MCKENNA

Subject: VBT-25-041 | Project Cannoli | NE Corner of Haggerty and I-94 NSD | SPR #2 (Preliminary); Plans Updated: January 30, 2026.

Source: Applicant's Submission with Labels Added

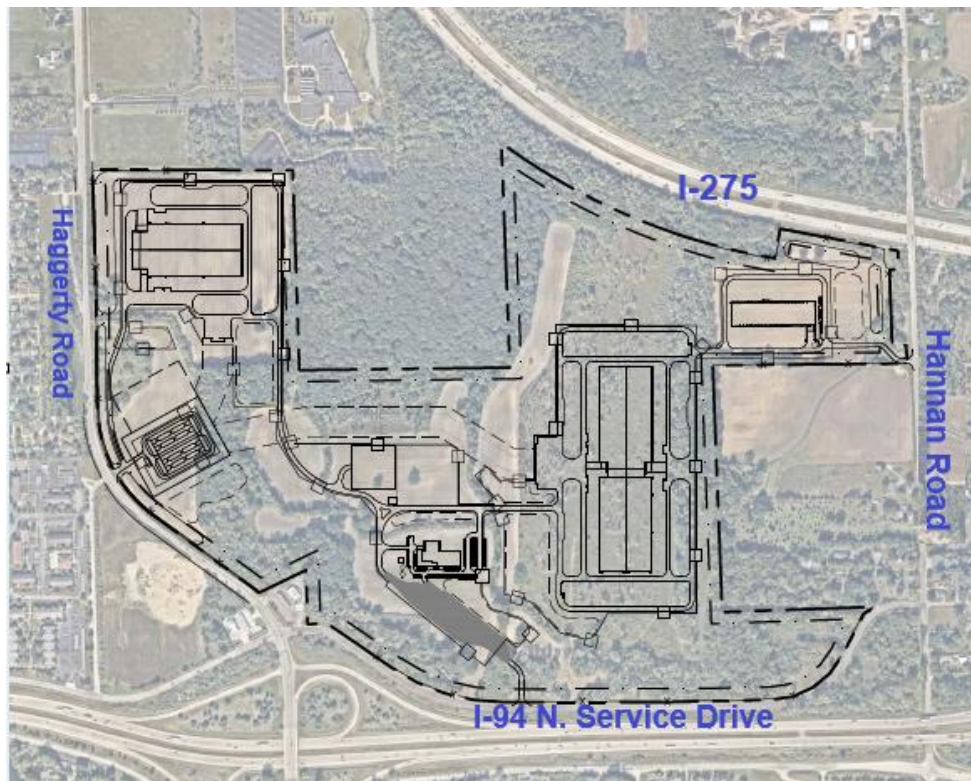
The applicant, Panattoni Development Company proposes to construct 4 buildings with a total footprint of 816,000 square feet upon an undeveloped tract of land. The subject site comprises numerous parcels with a combined area of 282.2 acres and is owned by Triple Creek Associates LLC. The applicant proposes to combine all of the parcels as part of the site plan approval process. The parcel is bounded to the north by I-275 and Wayne Community College, on the west by Haggerty Road, on the south by I-94 North Service Drive and on the east by Hannan Road, vacant farmed land and few single-family residences.
